Point Beach Nuclear Plant, Units 1 and 2
Dockets 50-266 and 50-301
Renewed License Nos. DPR-24 and DPR-27

License Amendment Request 261, Supplement 4
Extended Power Uprate

LICENSE AMENDMENT REQUEST 261, SUPPLEMENT 4 EXTENDED POWER UPRATE

**TRAIN "B" EMERGENCY DIESEL GENERATOR
VOLTAGE AND FREQUENCY PROFILES
LARGE BREAK LOSS OF COOLANT ACCIDENT
WITH LOSS OF OFFSITE POWER**

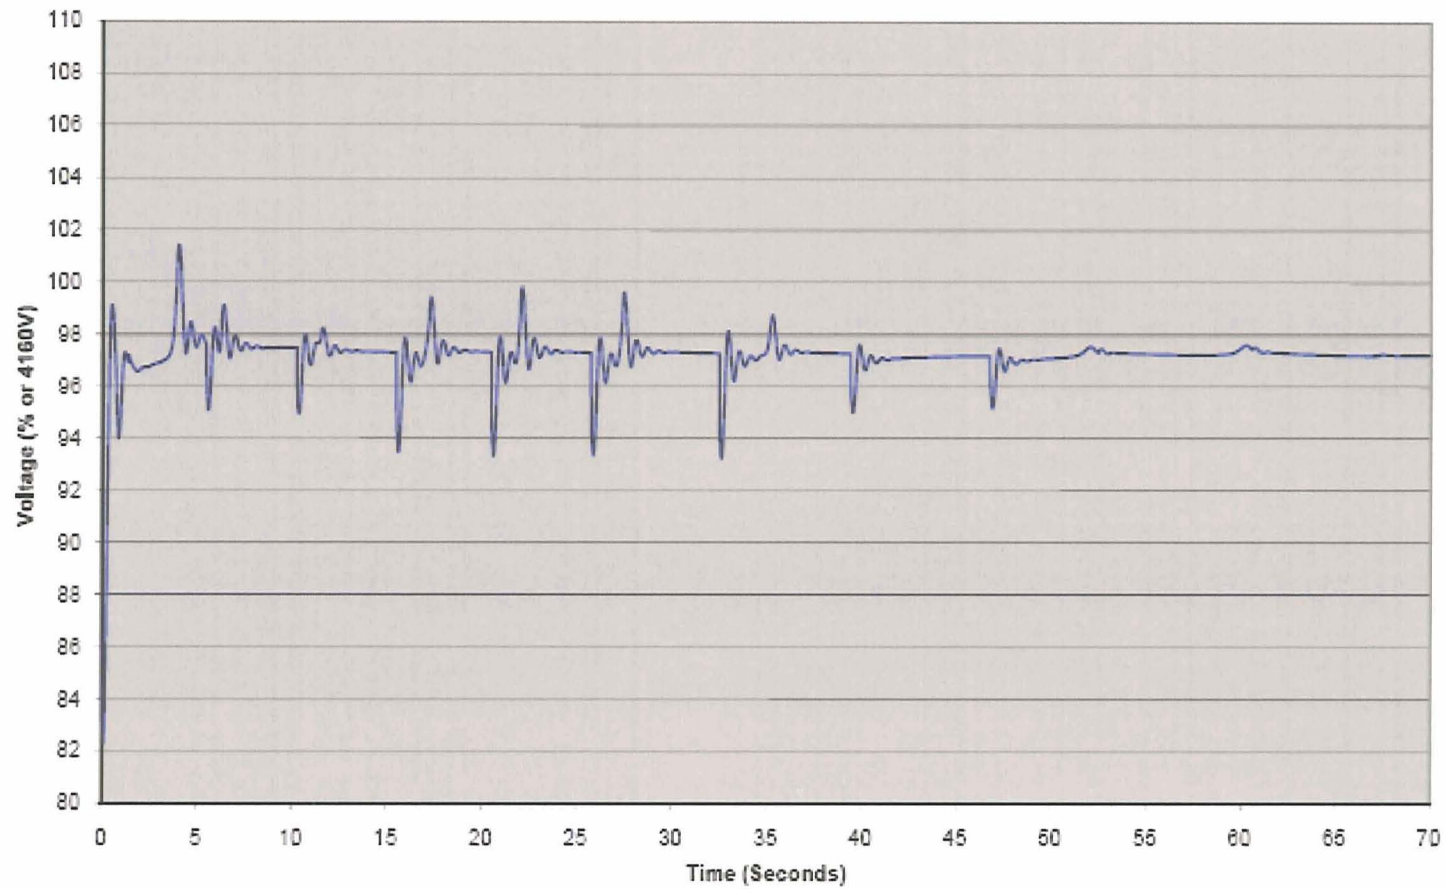
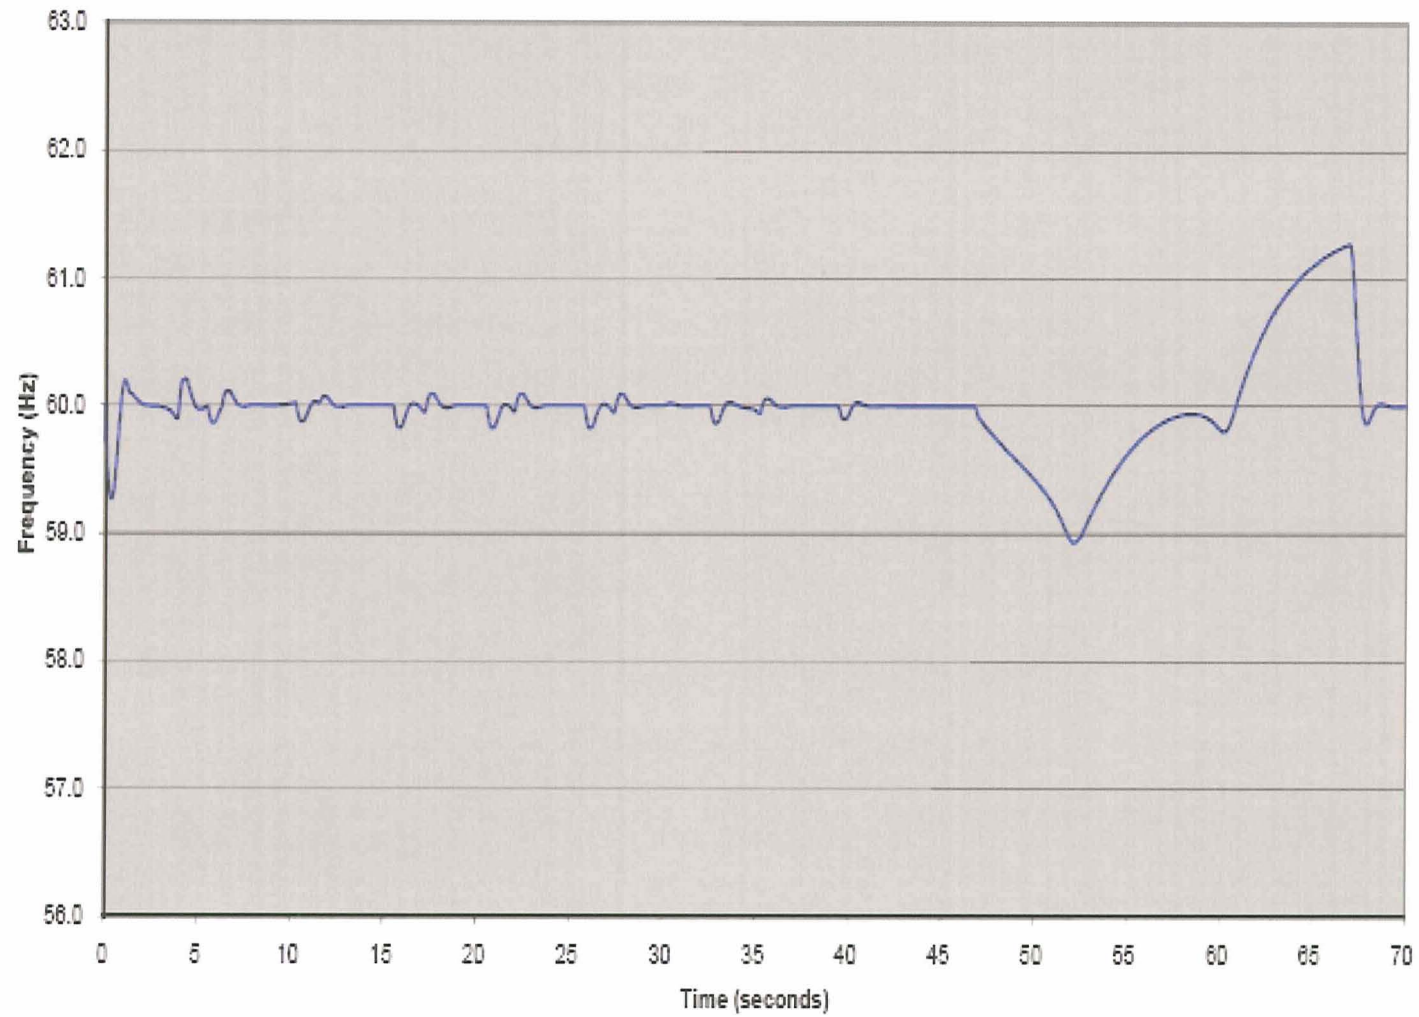
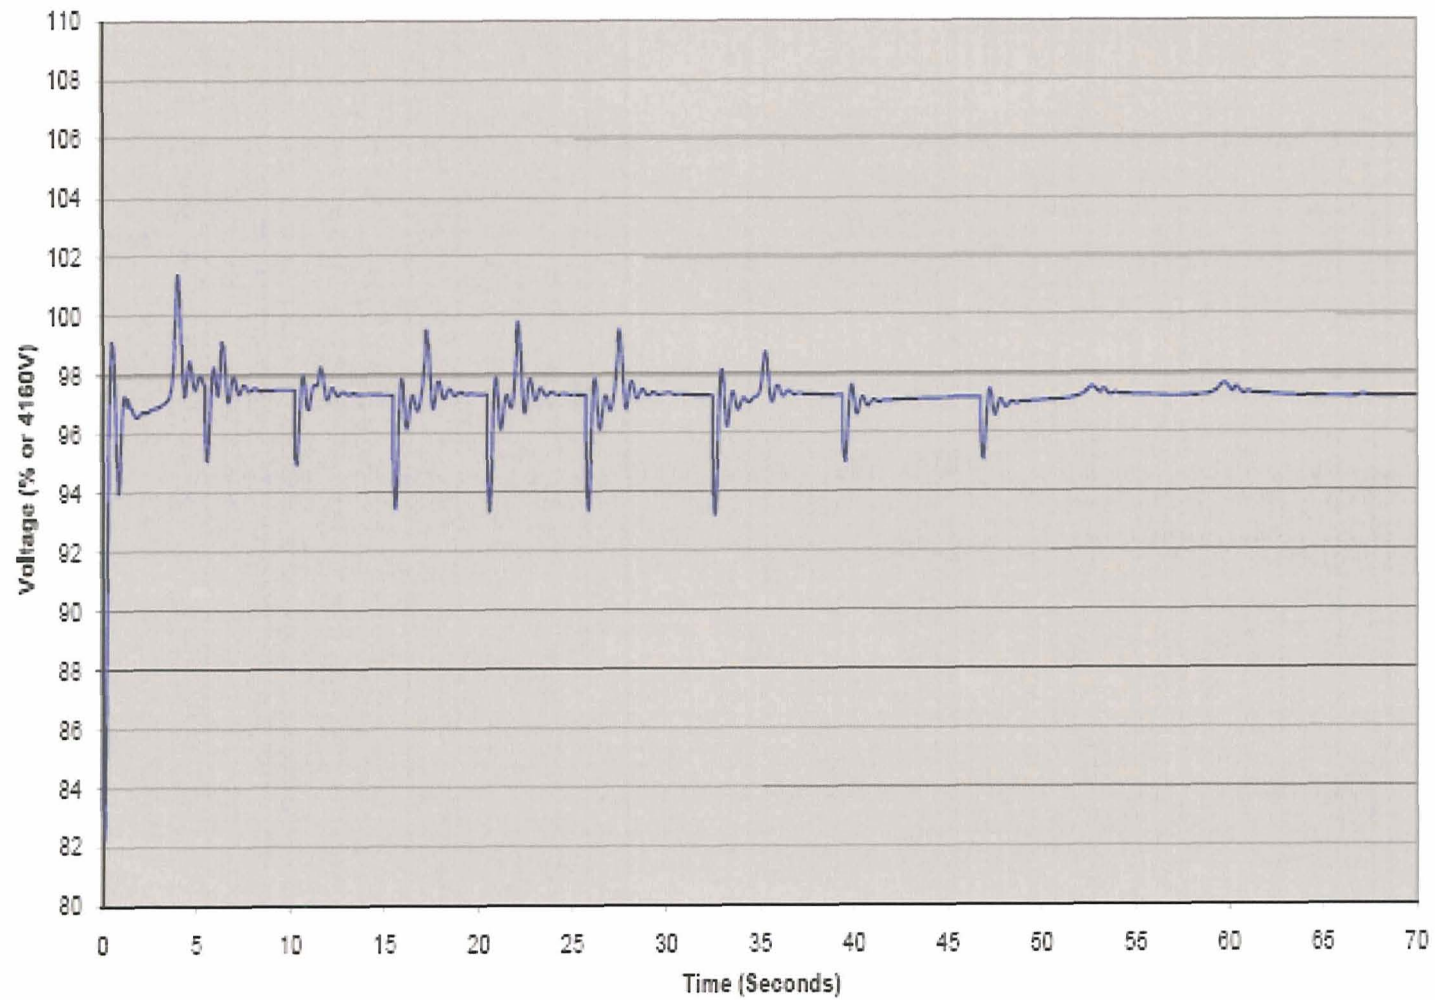
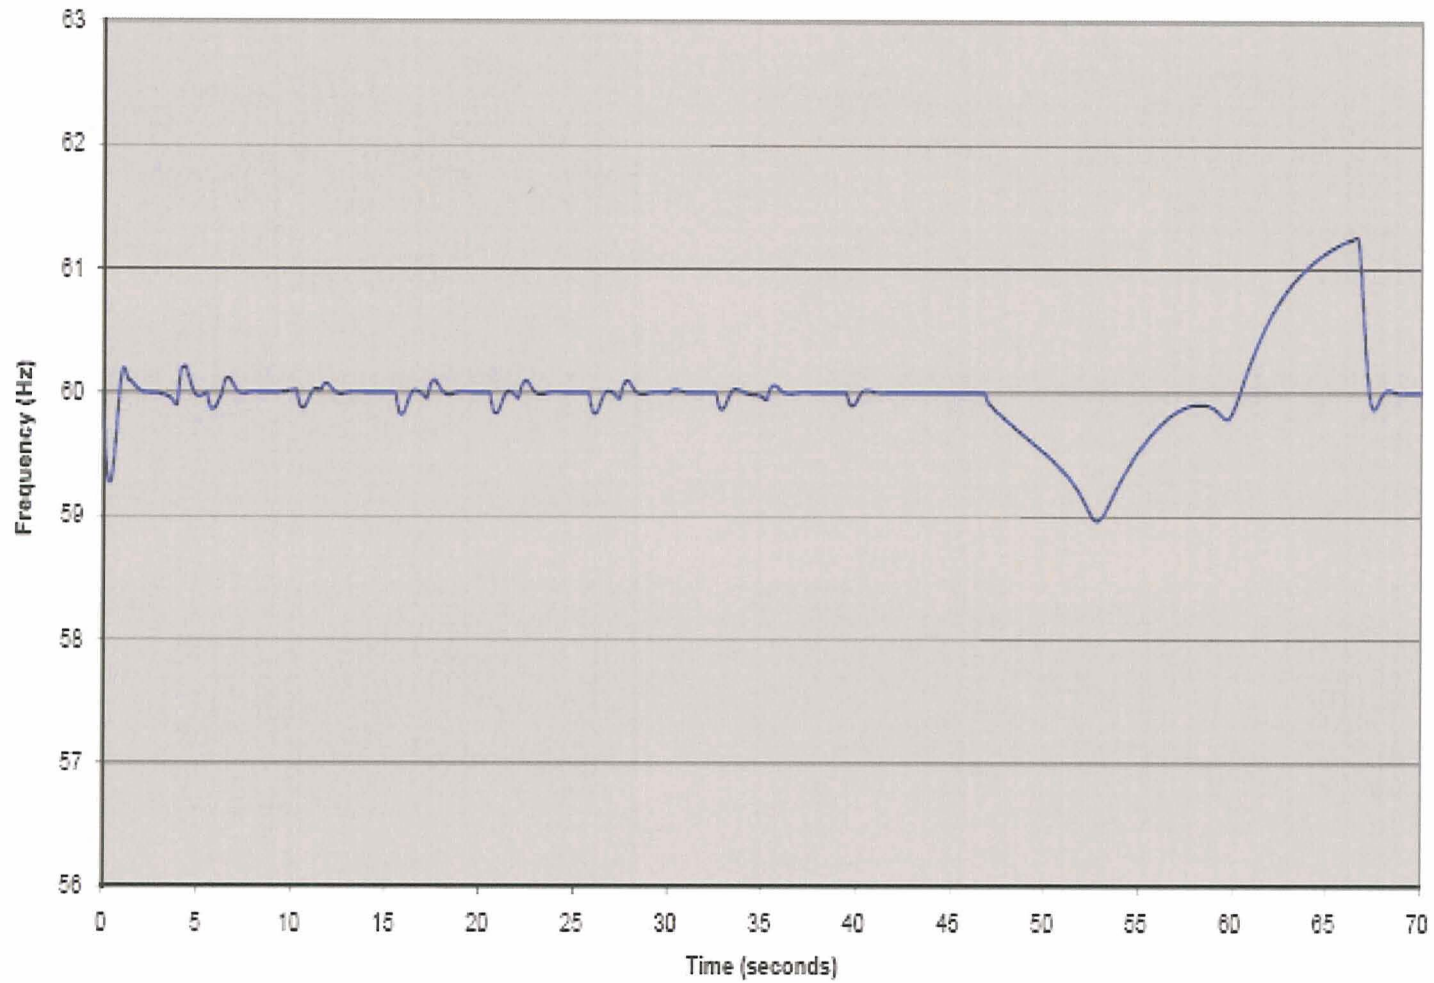
In response to staff's request for additional information (RAI) dated August 26, 2009, regarding the emergency diesel generator (EDG) voltage dip below the acceptance limit of 75 percent nominal voltage during motor start, the licensee stated that the EDGs are capable of starting safeguard loads, and the voltage recovers quickly to the acceptable level. Based on staff's review of the dynamic loading calculations, the staff notes that under certain loading conditions for Train "A" EDG, the frequency is outside 2 percent margin, the worst-case voltage dip is 45-48 percent and the voltage overshoot is 129.5 percent. Train "A" voltage and frequency variations are outside the industry accepted standards and guidance. Provide detailed analyses regarding the downstream effects on components such as contactors, control fuses, inverters, battery chargers, solenoids, motor-operated valves, solid state devices, etc., and the basis to show that all required loads will start and continue to run with sufficient margins after accounting for any uncertainties. Provide justification for the performance capabilities of the EDG "A" regulator and excitation systems to support shutdown equipment within design-basis requirements during a design-basis accident. The staff notes that Train "B" EDG bus voltages remain above 75 percent of nominal voltage, consistent with NRC Regulatory Guide (RG) 1.9, throughout the motor starting sequence in all postulated loading conditions. Provide a summary of all bus voltages for the 'B' train distribution system.

Case #	Case Description
7-1	EDG G-03/G-04 Unit 1 LOOP/LOCA with Unit 2 LOOP
10-1	EDG G-03/G-04 Unit 1 LOOP with Unit 2 LOOP/LOCA

The EDG voltage and frequency traces for these cases are included in Attachment 4. Other non-large break LOCA design basis accident ETAP cases were also performed for the Train "B" EDGs for cases where the containment spray pump starts in later load blocks. For these cases, the EDG voltage and frequency also remain within Regulatory Guide 1.9 limits.
